ITEM FOR ENVIRONMENTAL COMMISSION AGENDA

NAME & NUMBER OF PROJECT: 8020 Parmer Lane SH 130 NW
C8J-2021-0141.0A

REQUEST: Variance request is as follows:
1. Request to vary from LDC 30-5-342 to allow fill over 4 feet to 15 feet.
2. Request to vary from 30-5-261(G) to allow floodplain modification in a critical water quality zone buffer.

Development Services Department
Staff Recommendations Concerning Required Findings

CUT - FILL PLAN

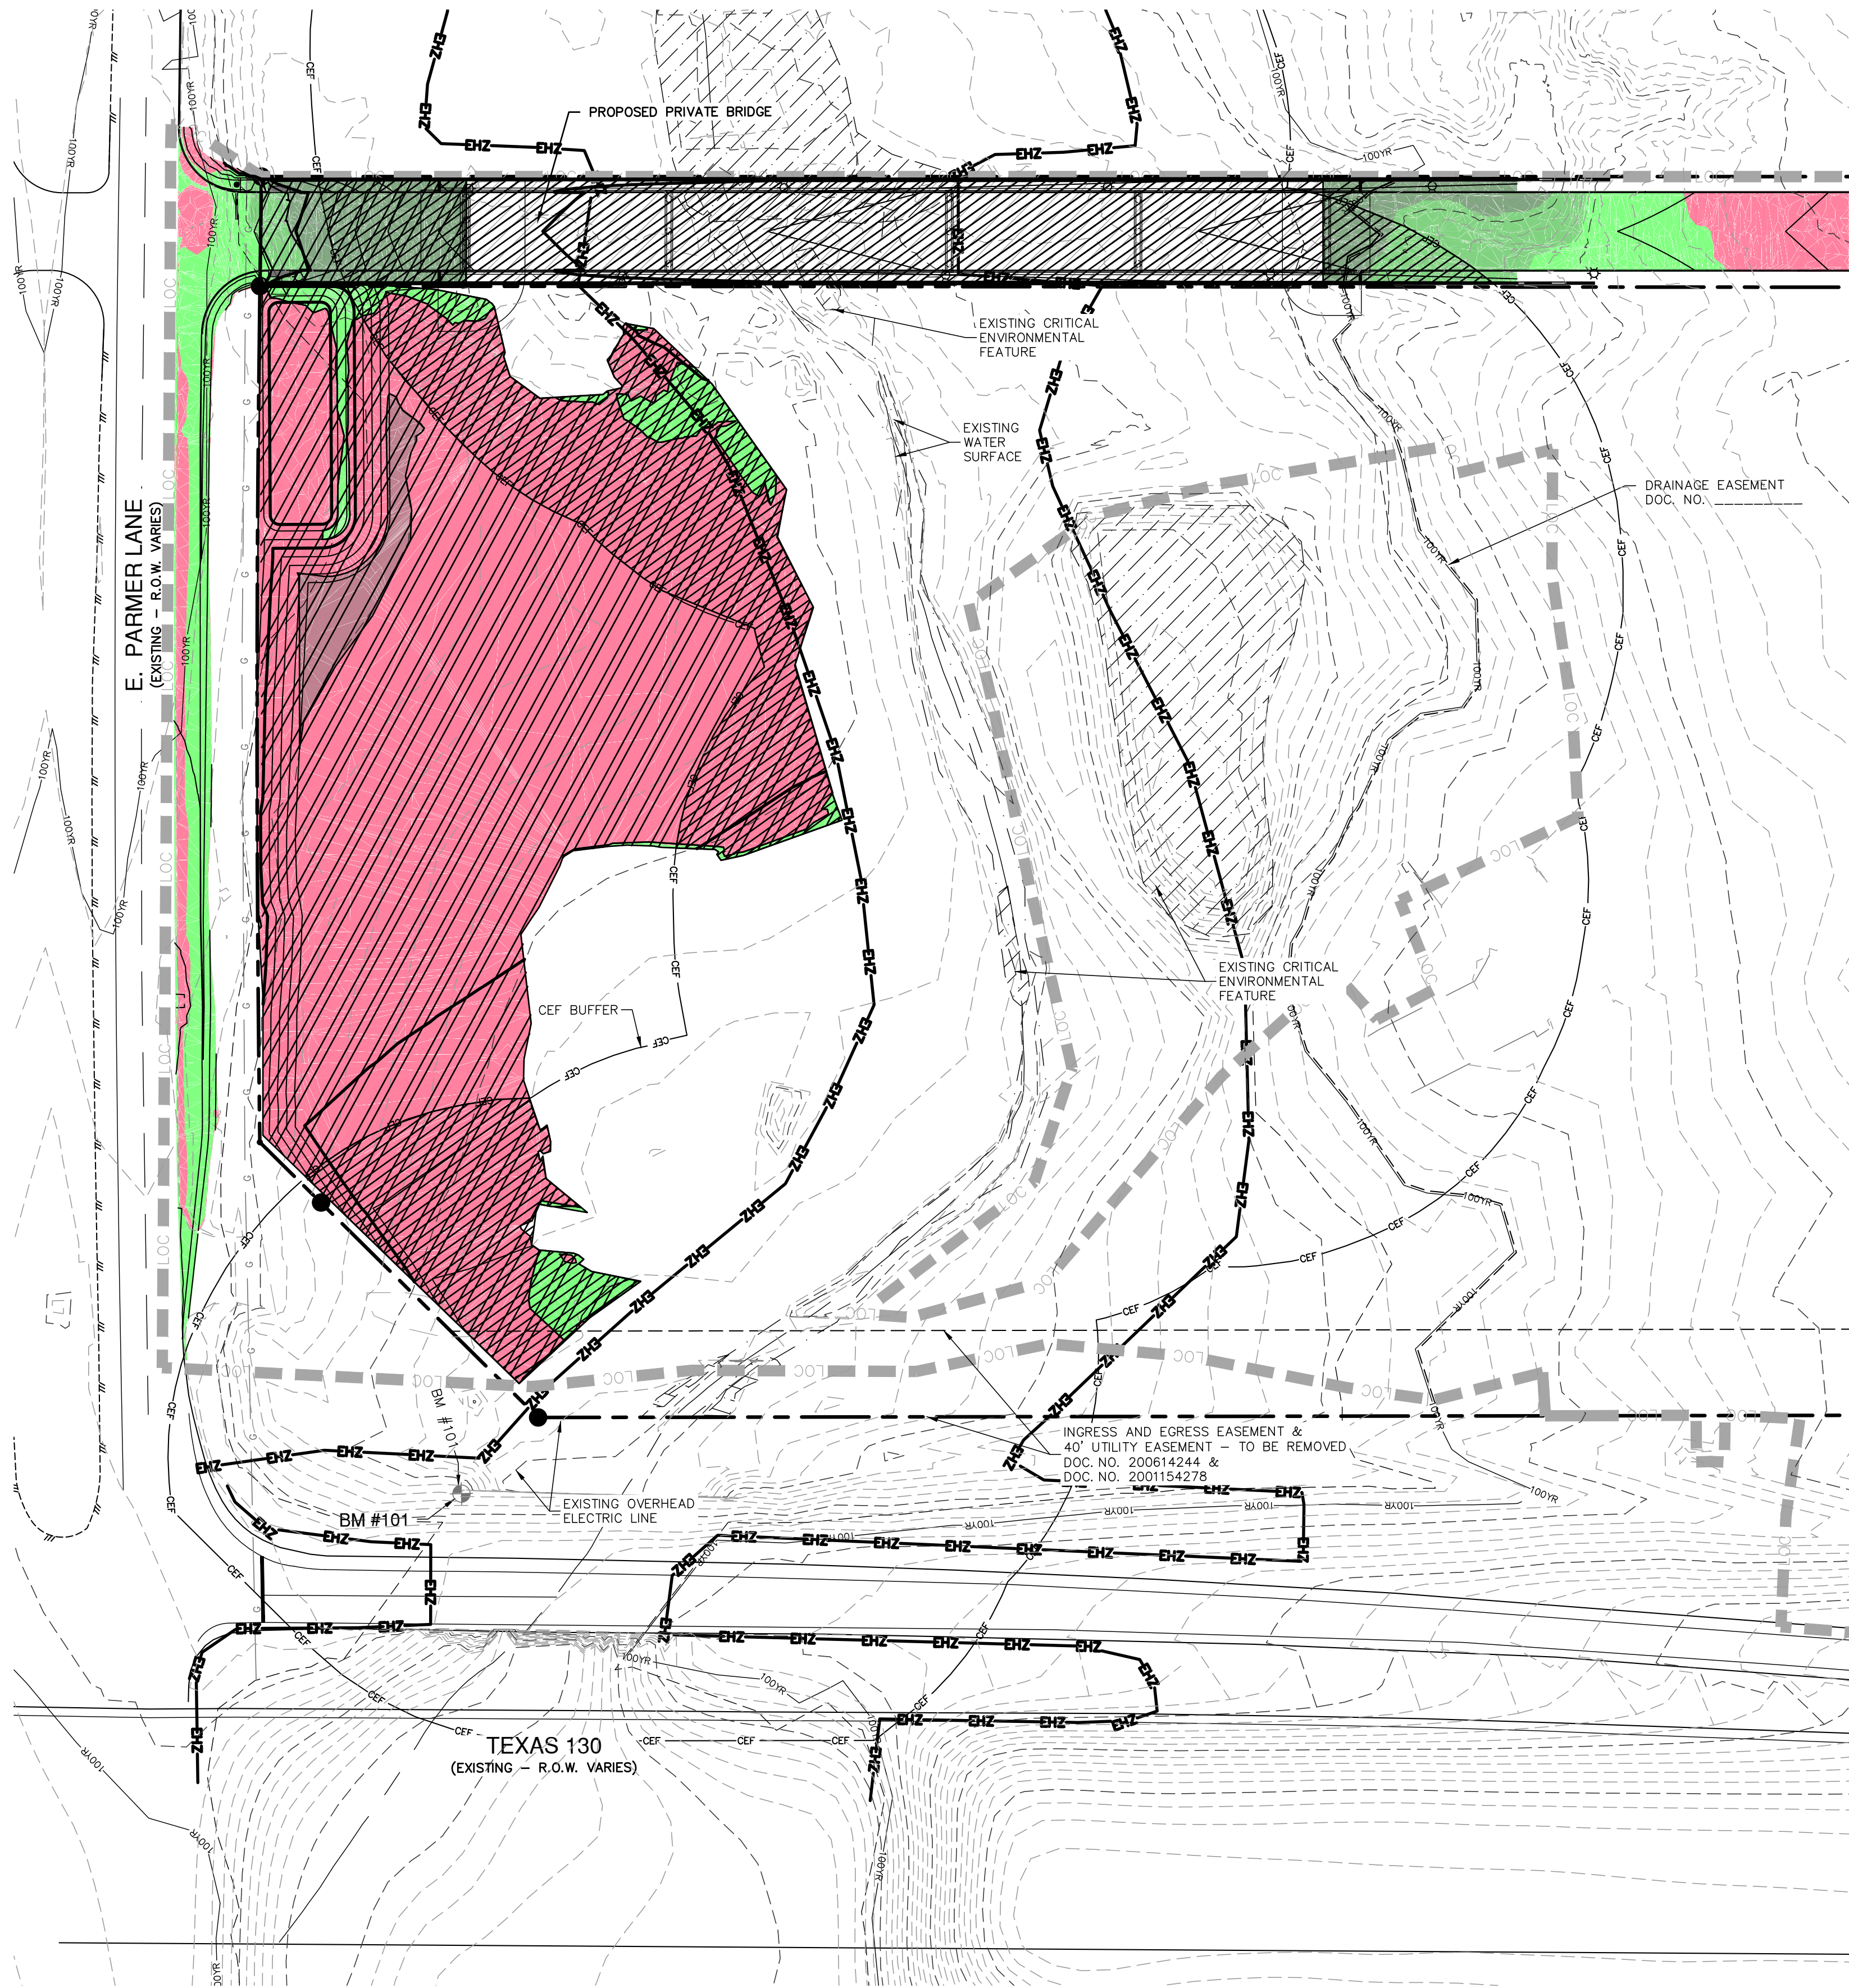
The fill variance is required in order for the applicant to access the site with a bridge spanning wetlands, floodplain, and creek buffer.

Yes The variance for fill is the minimum necessary to build the bridge to a height that will allow safe access to the site across the floodplain.

Yes The proposed fill is the minimum necessary to build the bridge to access the property.

Yes : The minimum fill over 4 feet is proposed to build the bridge so that the low chord of the bridge is 2' above the 100 yr water surface elevation of the 100 yr floodplain, as required for safe access by code. Additionally, two developments will use this access point as a joint use access drive, to limit the modification of the floodplain and environmental features along the property frontage. Please see attached cut and fill exhibits.

Floodplain Modification

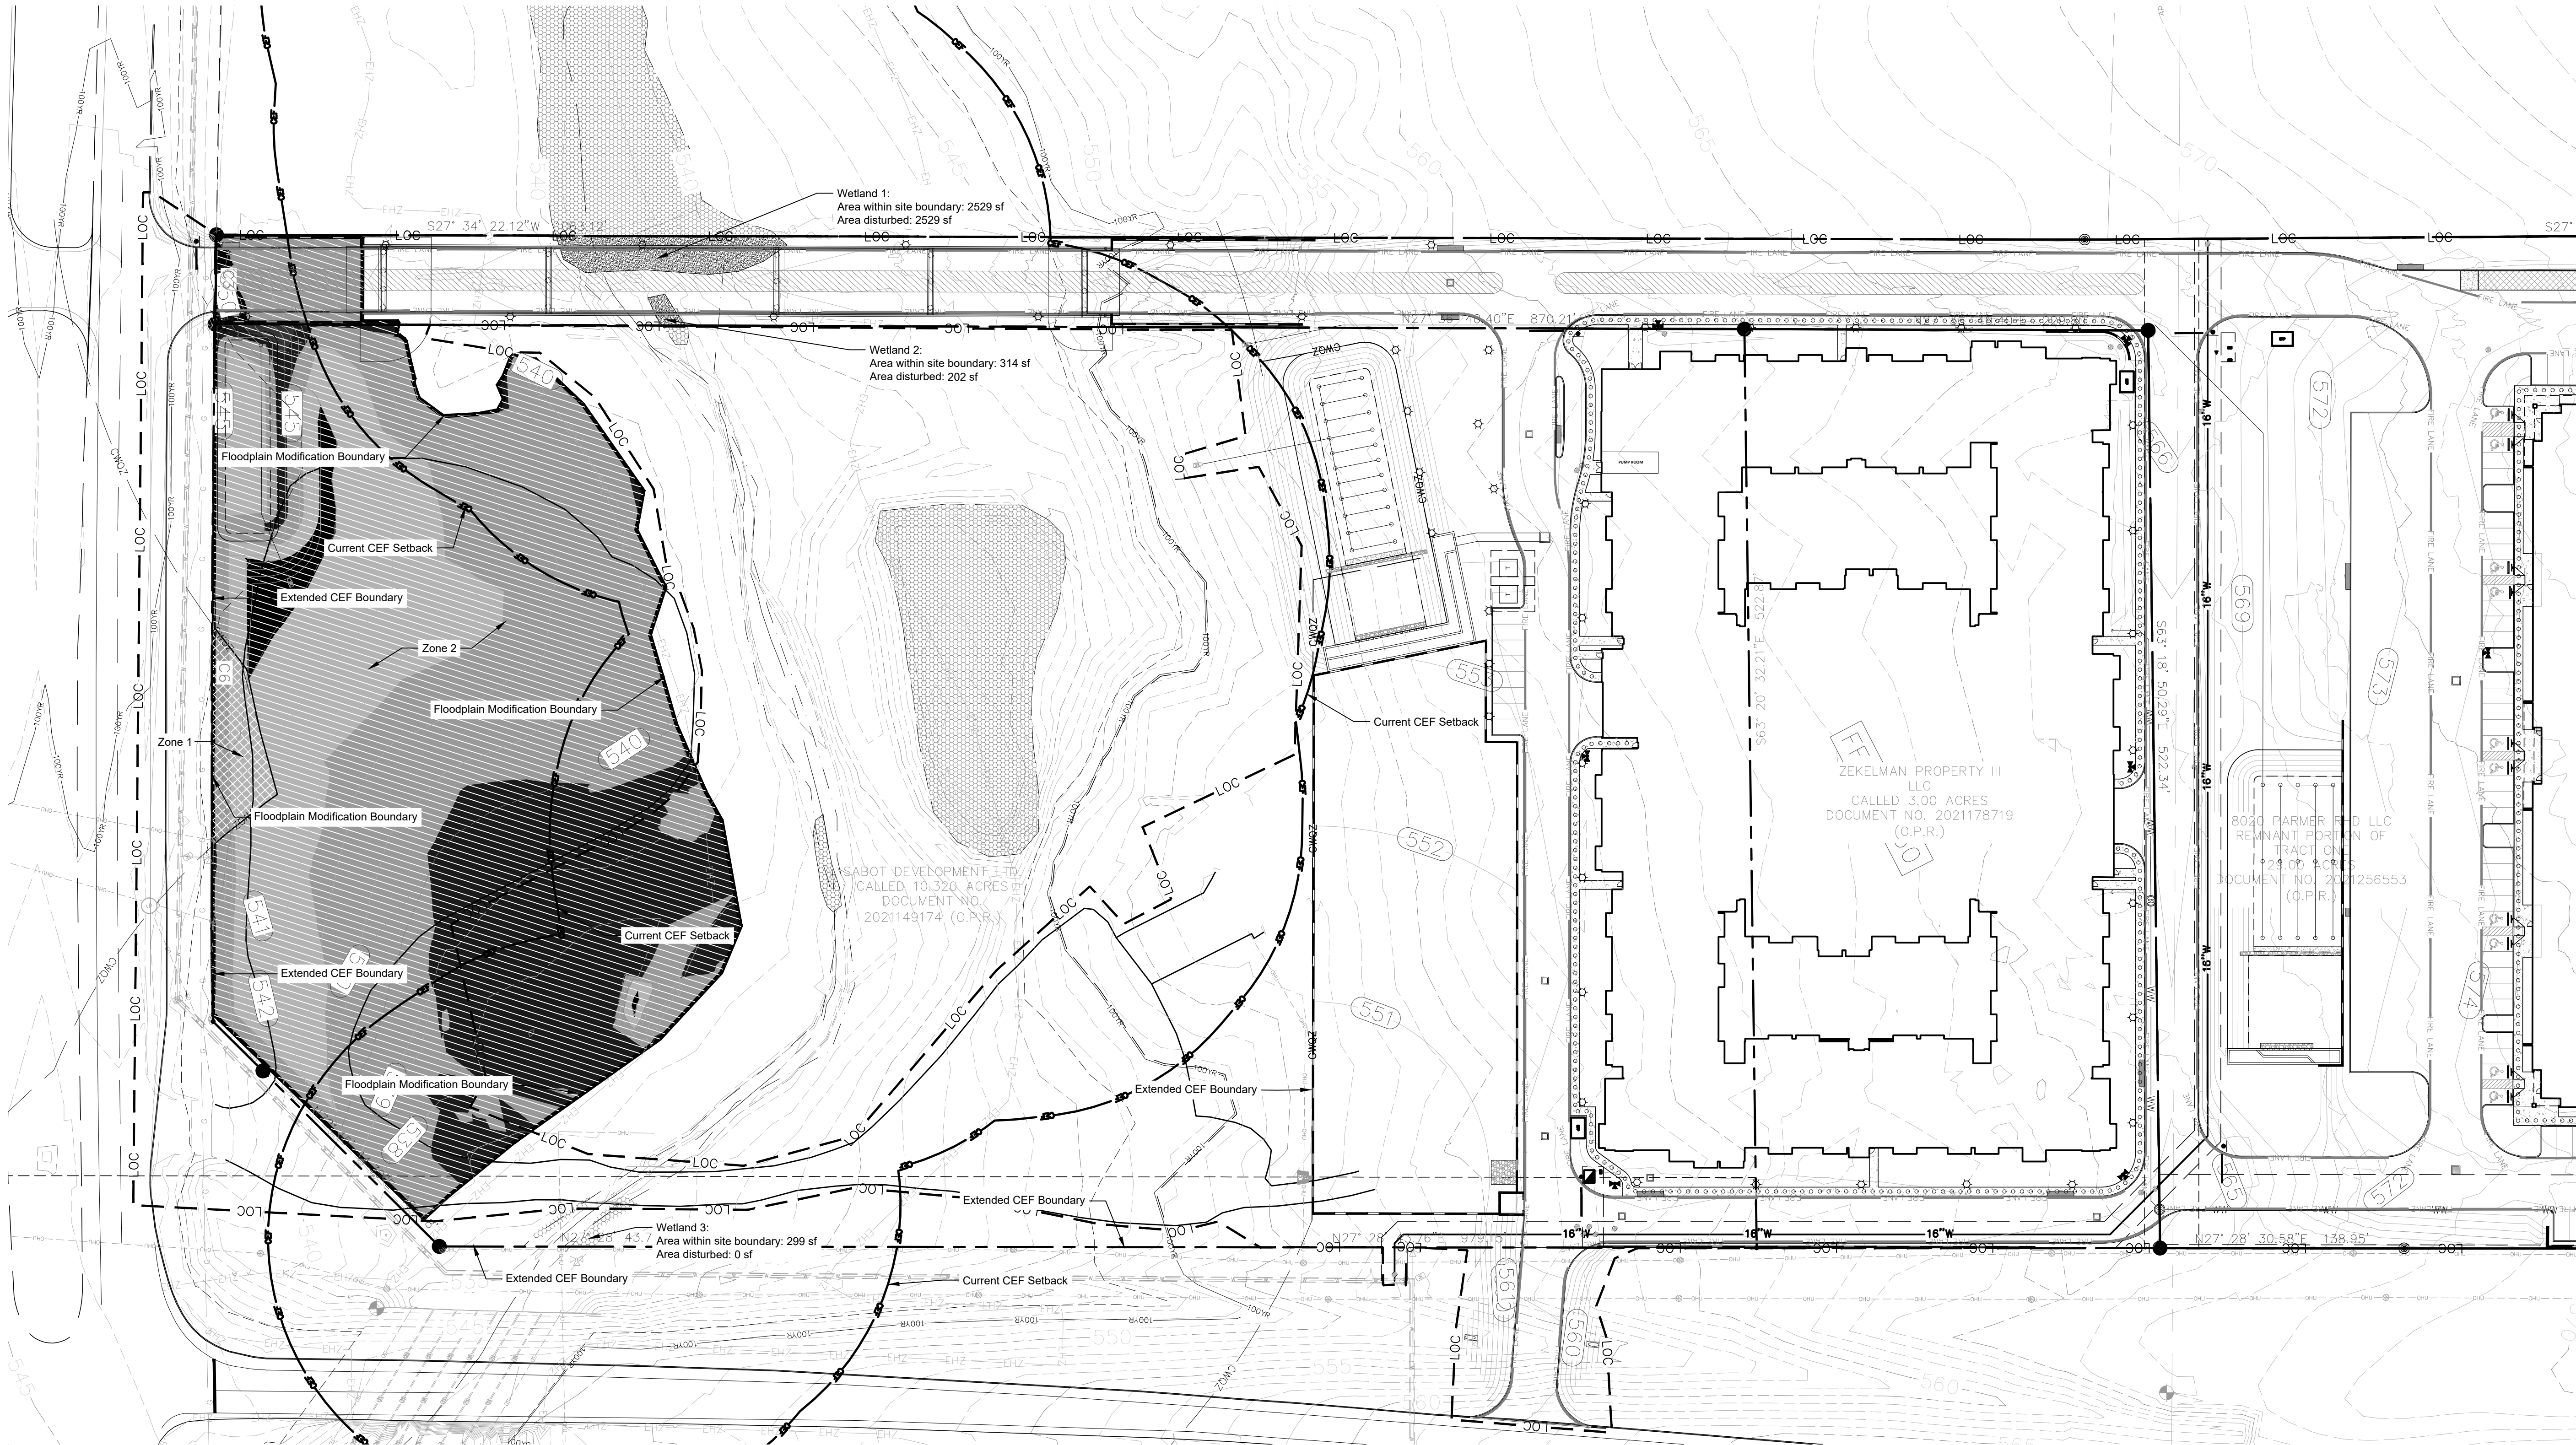
The Critical Water Quality Zone variance is required because floodplain modification is necessary to offset the floodplain volume displaced by the bridge. There are no adverse impacts proposed to the floodplain elevations on adjacent properties with the proposed improvements, per the requirements of the code.

Yes The proposed floodplain modification is the minimum necessary to build the bridge as required by code for safe access, with the low chord of the bridge two feet above the water surface elevation of the 100-year floodplain.

- The minimum grading modification in the floodplain and Critical Water Quality Zone is proposed to build the bridge so that the low chord of the bridge is 2' above the 100 yr water surface elevation of the 100 yr floodplain, as required for safe access by code.

STAFF CONDITION: Staff recommends the following conditions:
1. The applicant will pay into the Riparian Zone Mitigation Fund for both the area of Zone 1 (Floodplain outside of the CWQZ) and the area of Zone 2 (Floodplain within the CWQZ) using the appropriate ratios per ECM 1.7.6.
2. Development of the site will be carried out as described in Exhibits 1-6, attached in the staff variance packet.
